# ADDENDUM

ADDENDUM NO: 2

PROJECT: Hamilton Heights High School Phase 2 Projects

DATE: 02/27/2024

C111

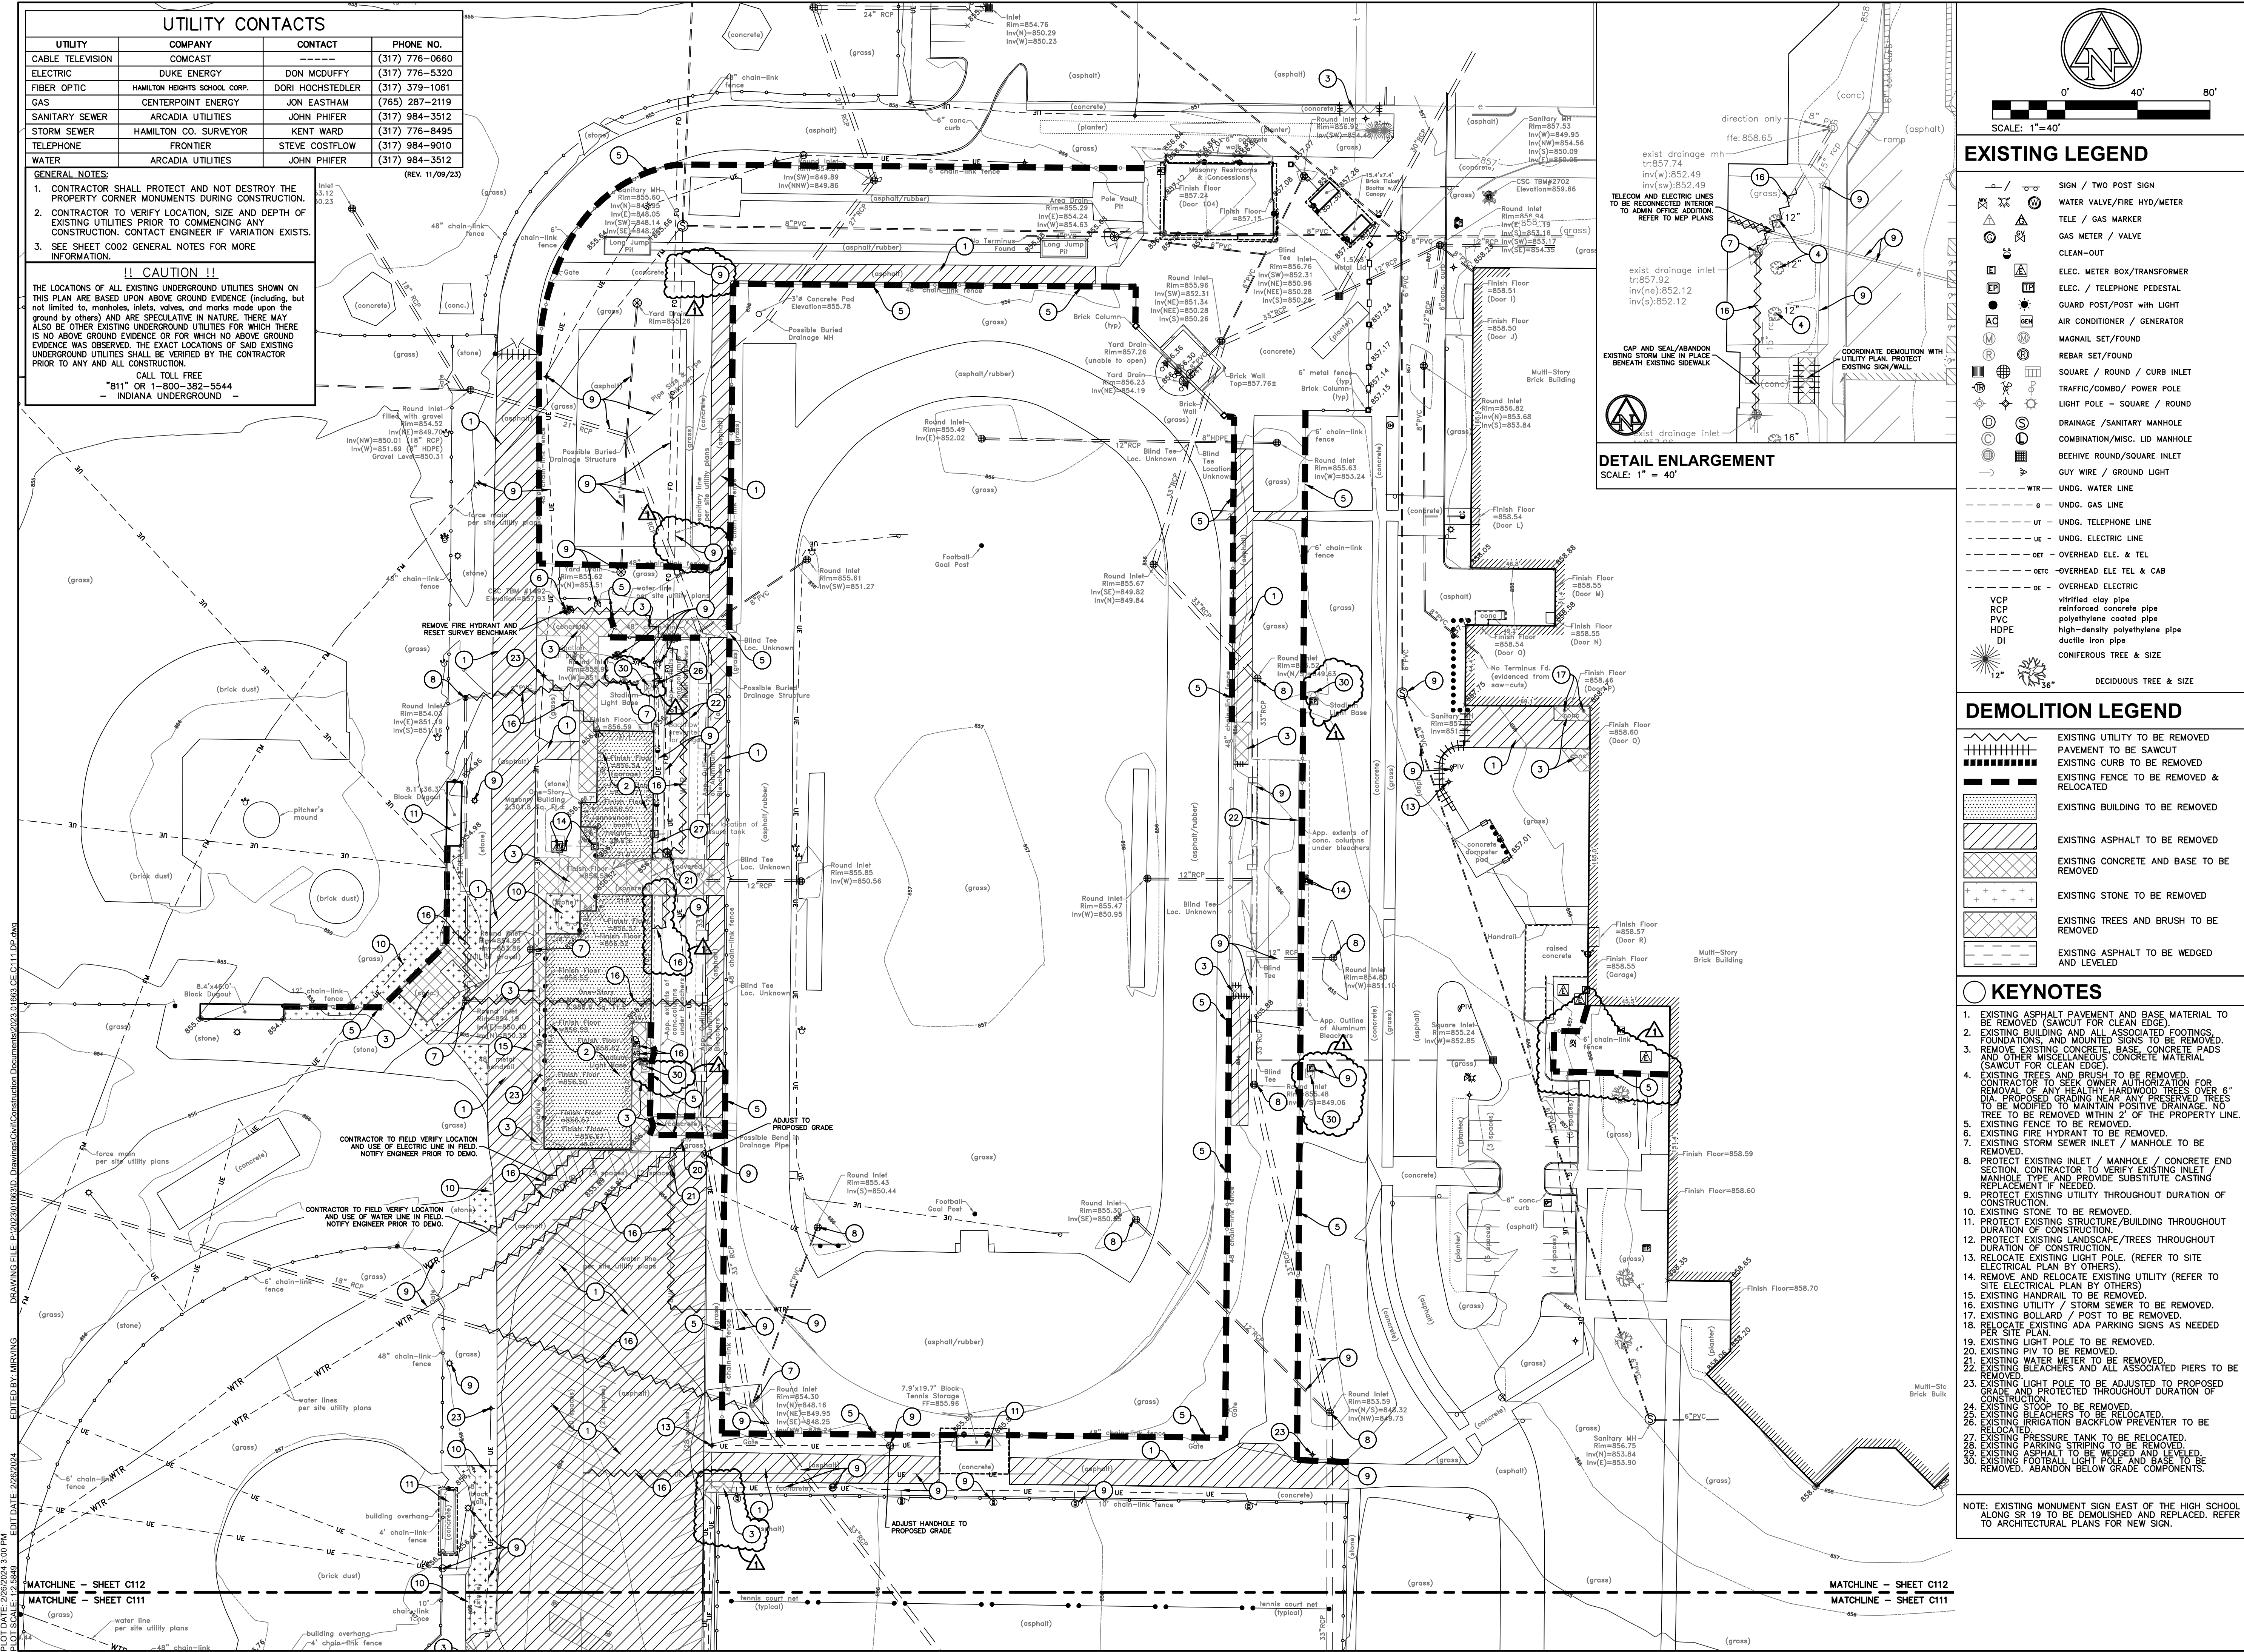
#### **3.1 C111 – DEMOLITION PLAN & C112 – DEMOLITION PLAN**

- A. Wedge and level shown for ADA parking area
- B. Keynote added for relocation of ADA parking signs
- C. Keynote added for removal of parking striping
- D. Keynote added for removal of football lighting
- E. Additional concrete removal shown at northwest corner of tennis courts
- F. Sanitary lateral no longer called out to be abandoned. Upstream portion called out to be removed per new sanitary connection to pressbox.
- G. Fence removal called out for utility equipment area south of AG Lab Addition.

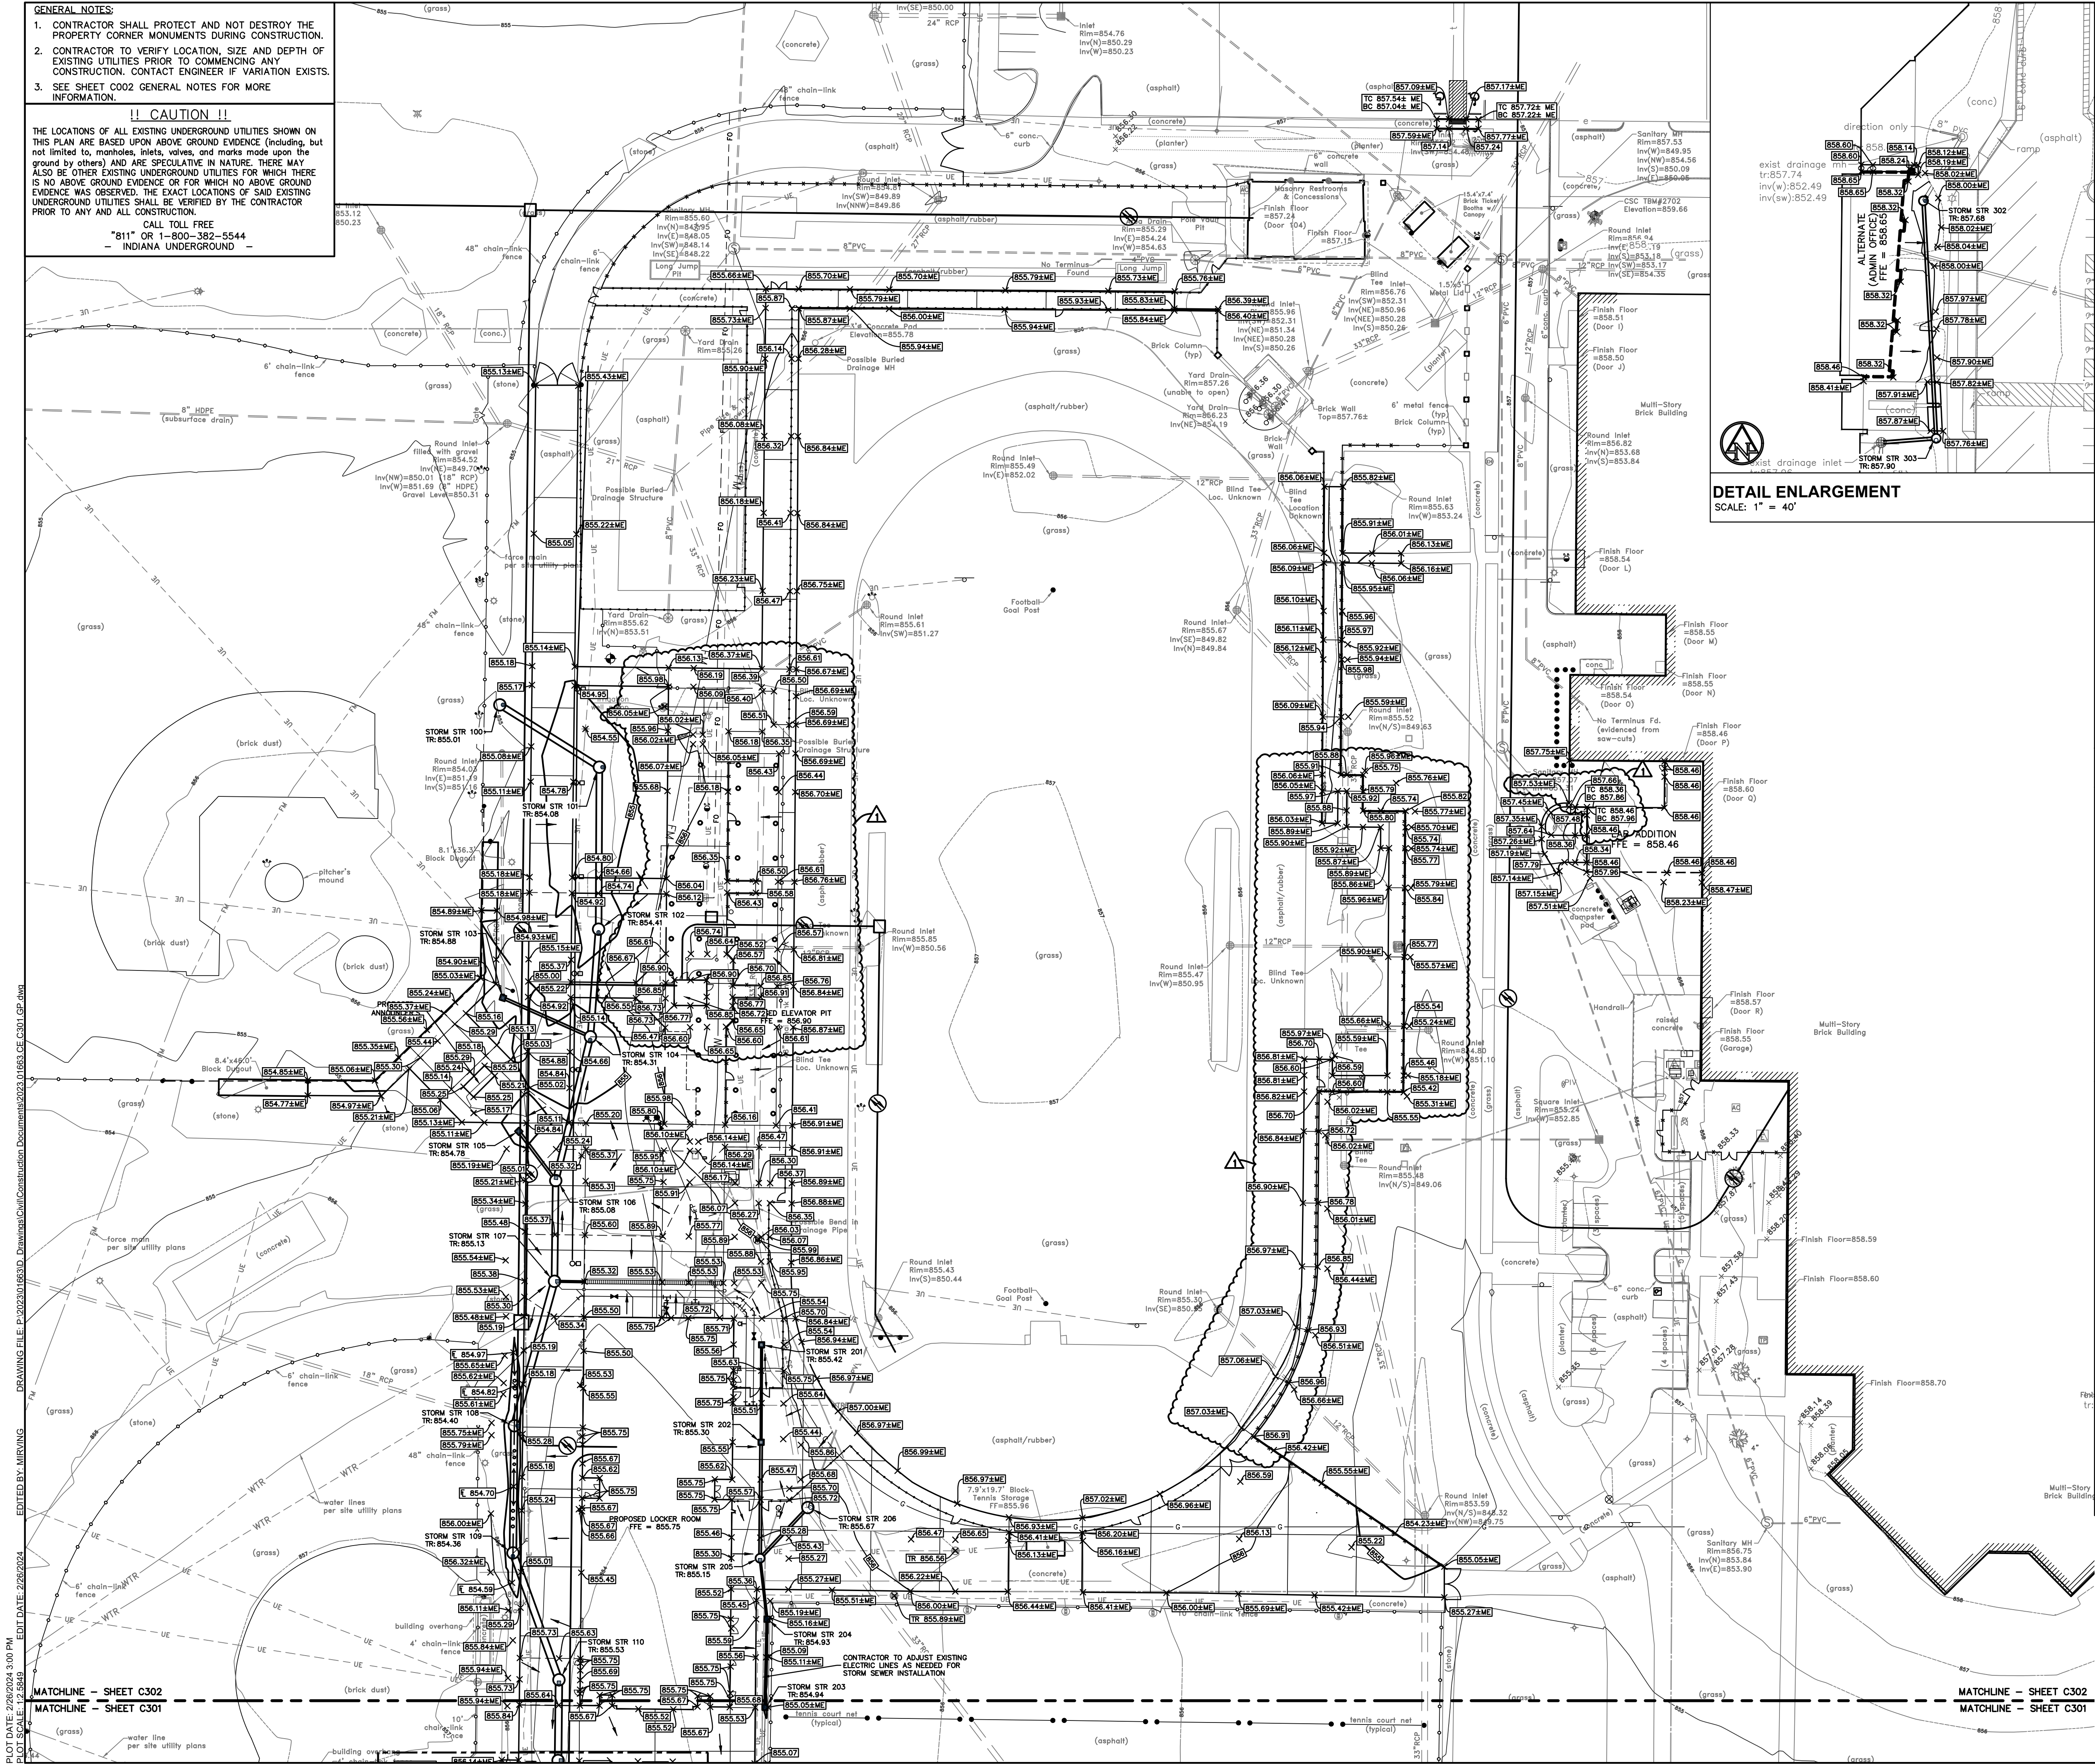
#### **3.2 C301 – GRADING PLAN, C302 – GRADING PLAN, & C303 – STORM STRUCTURE DATA TABLE**

- A. Grading revised for larger parking lot islands
- B. Grading revised to reflect 6" curb along parking entry drive
- C. Wedge and level shown for ADA parking spaces
- D. Grading shown for added walkway along southeast portion of track
- E. Elevator pit and mechanical room FFE adjusted to 856.90
- F. Curb shown for walk connected to AG Lab drive-in

**UTILITY PLAN**

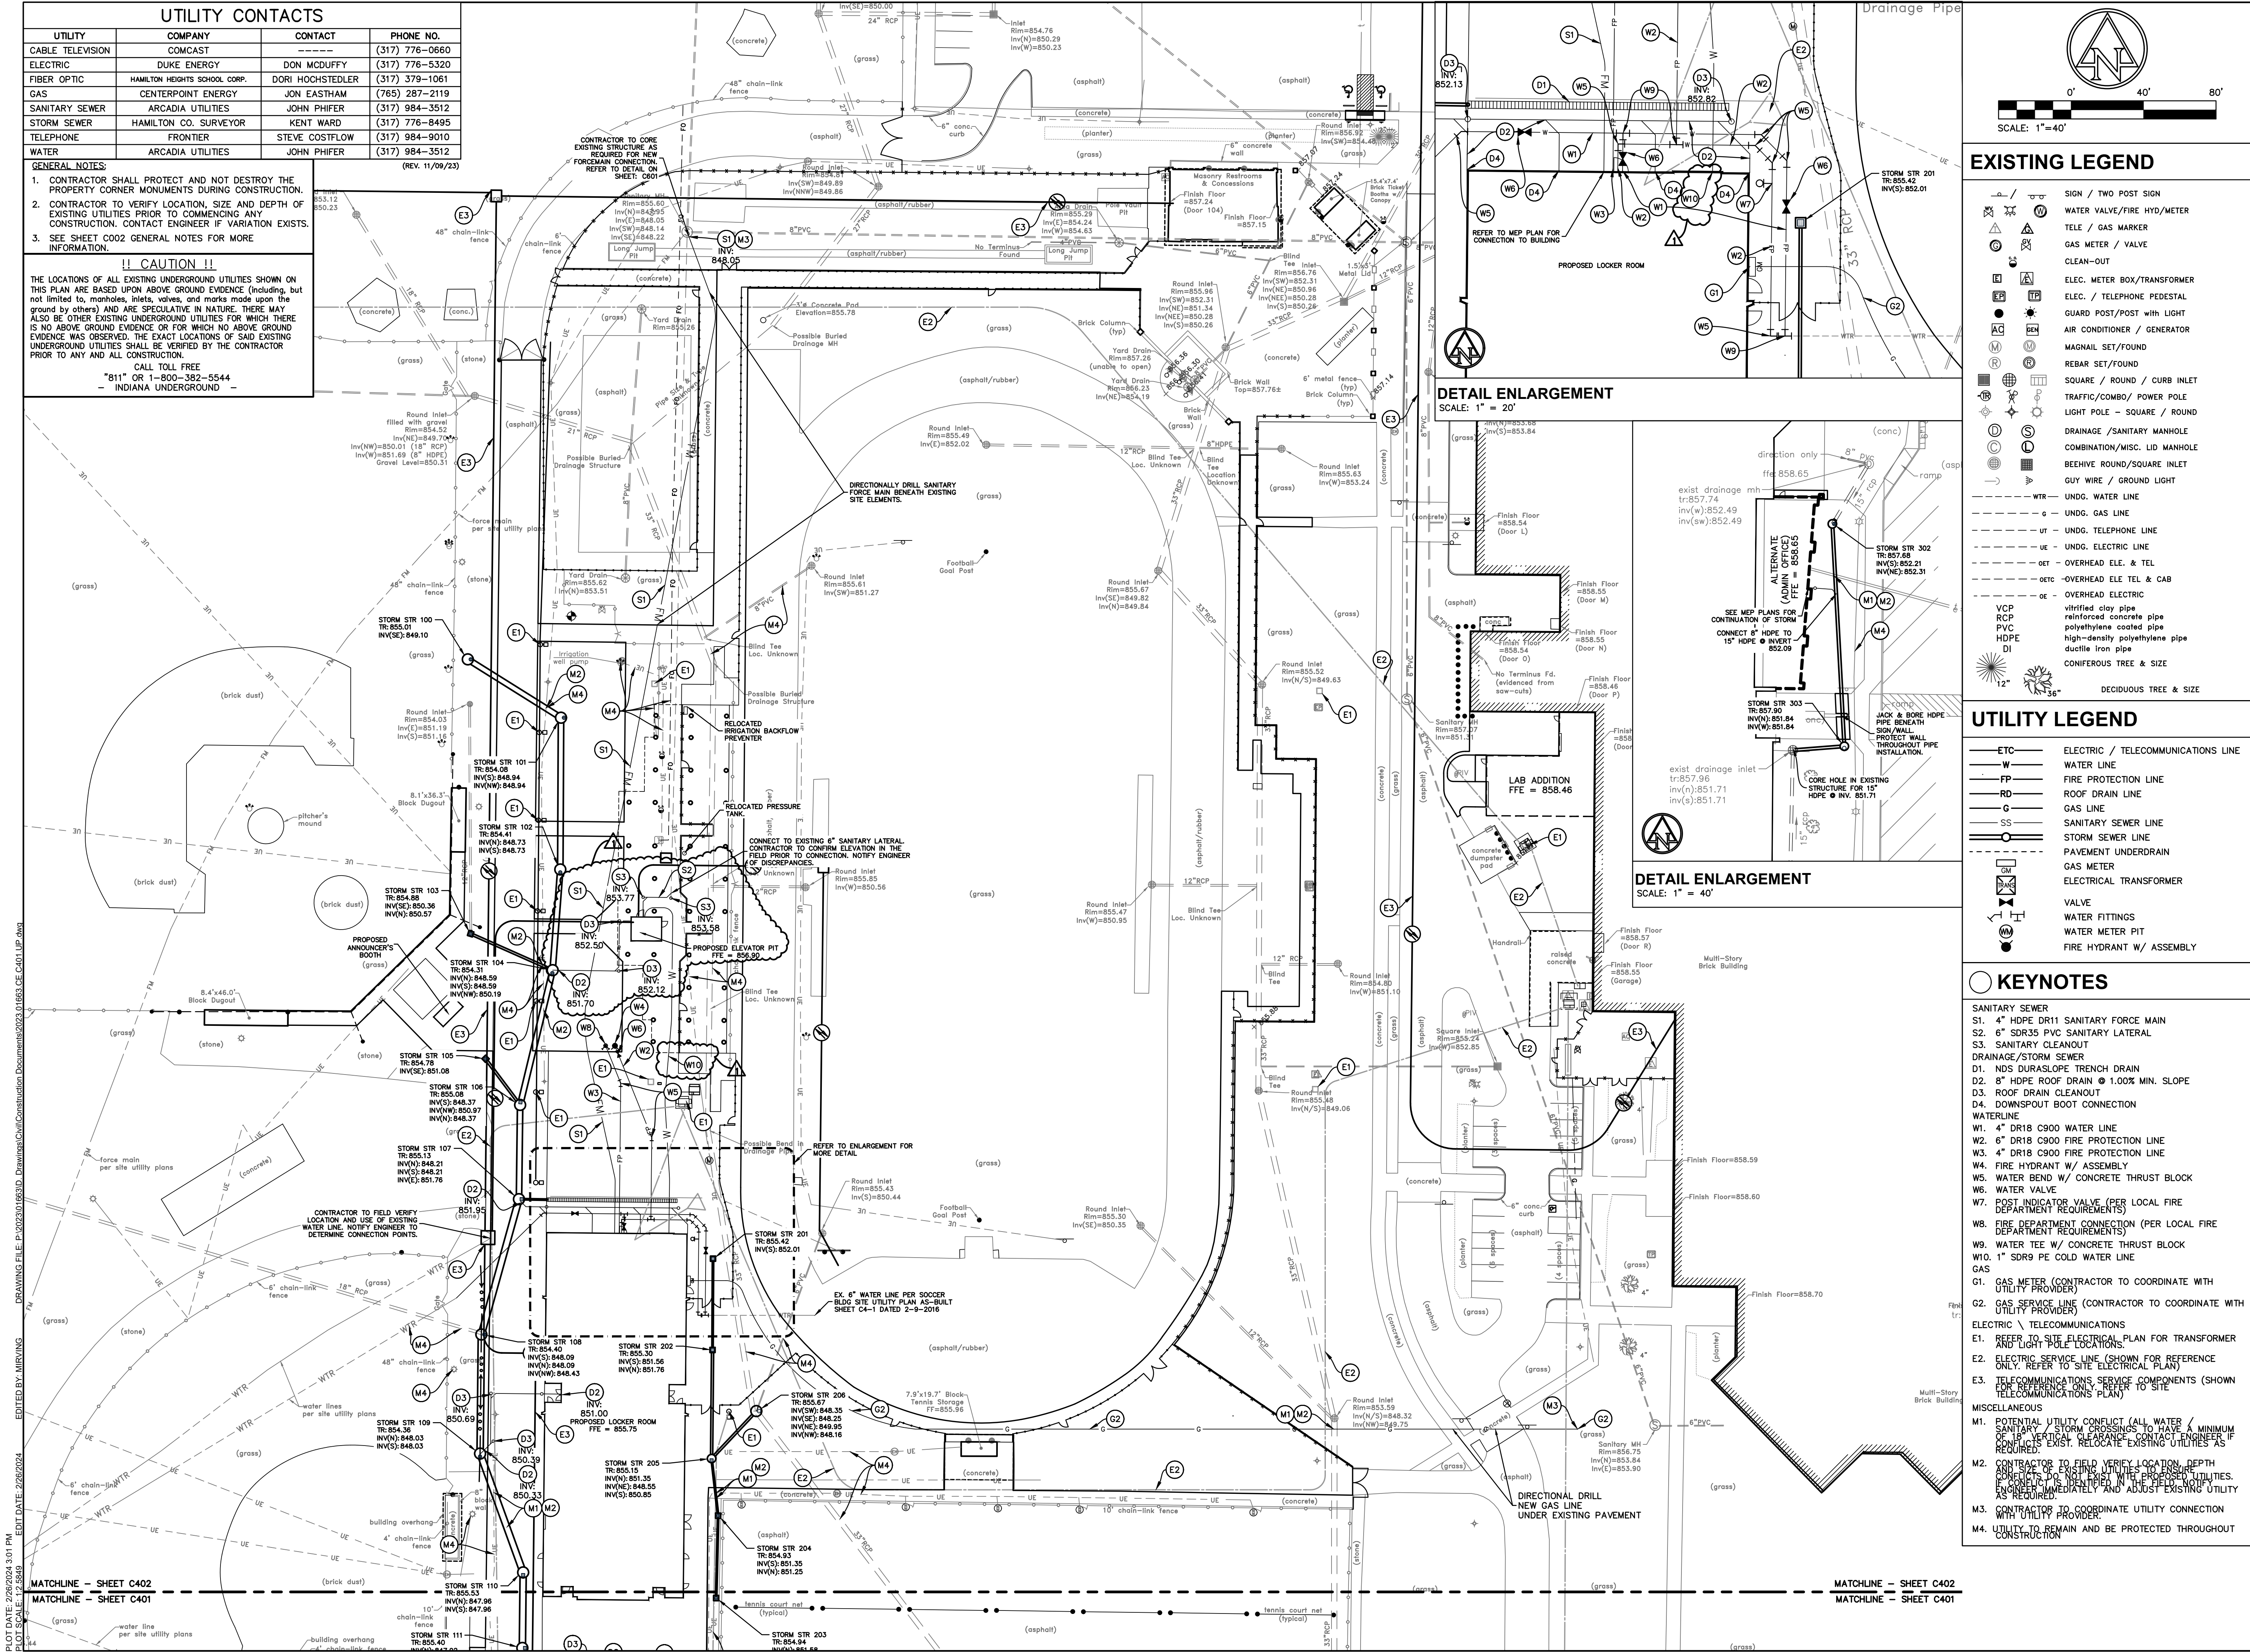
#### **3.3 C401 – UTILITY PLAN & C402 – UTILITY PLAN**

- A. Updated telecom and electrical linework shown for reference
- B. 1" water line to pressbox now in civil scope / keynote W10
- C. Roof drain added from pressbox
- D. Sanitary lateral added from pressbox
